DS-K1T341A Series MinMoe Terminal Release Notes (2023-10-19)

ARM:
Device Model:		ACS_641_AI3_EN_STD_V3.7.0_build231019
DS-K1T341AM	Firmware	ACS_641_AI3_EN_NEU_V3.7.0_build231019
DS-K1T341AMF	Version	MCU:
		ACS_DS-
Naming Rule:		K1T641_642_13.56M_ST1_GML_GM_V1.0.2_build231019
M for M1 card,	Software	HikCentral AC:
F for fingerprint	Version	https://www.hikvision.com/en/support/download/software/hikcent
		ral-access-control-v2-1/

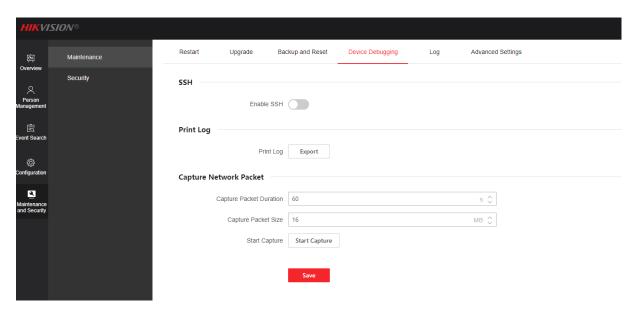
1. Add security issues and secure email (overseas) password retrieval function.

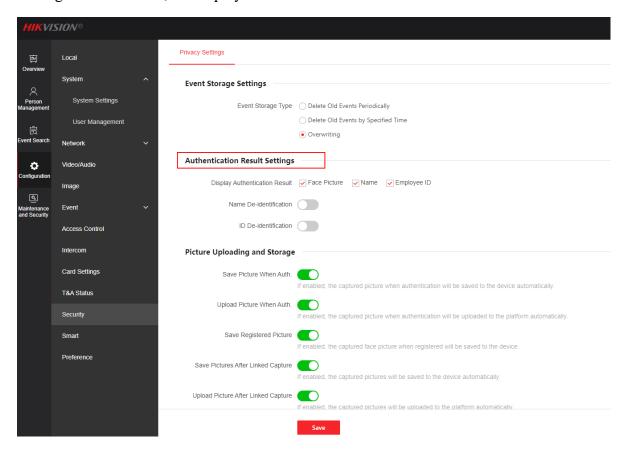
2. Add web network packet capture function.

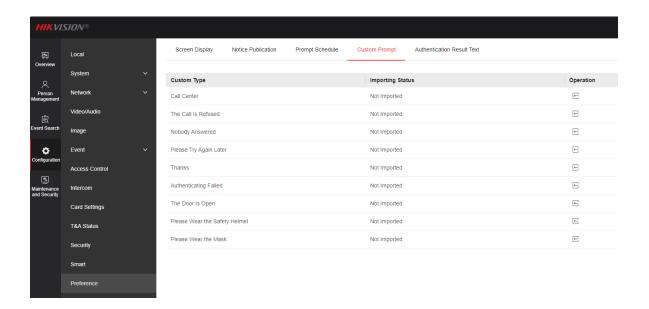
- 3. Add simple mode to the device display interface.
- 4. Support UI authentication result desensitization display of employee ID and name. After turning on the function, the displayed content will hide true information.

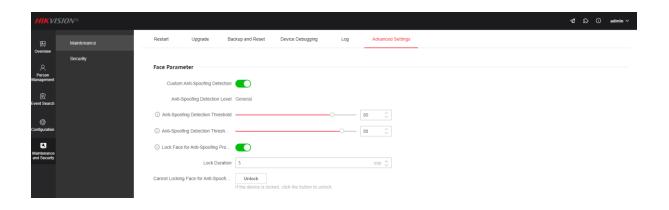
1. Improve the display effect of the interface.

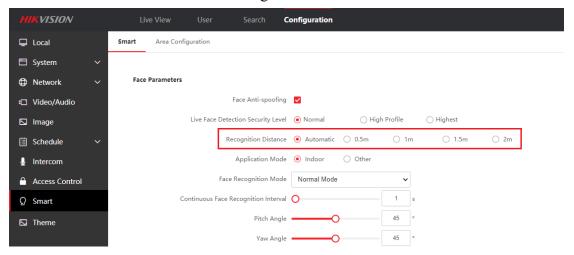
1. Add Hik-Connect menu in device UI Menu→Comm. The function is disabled in default.
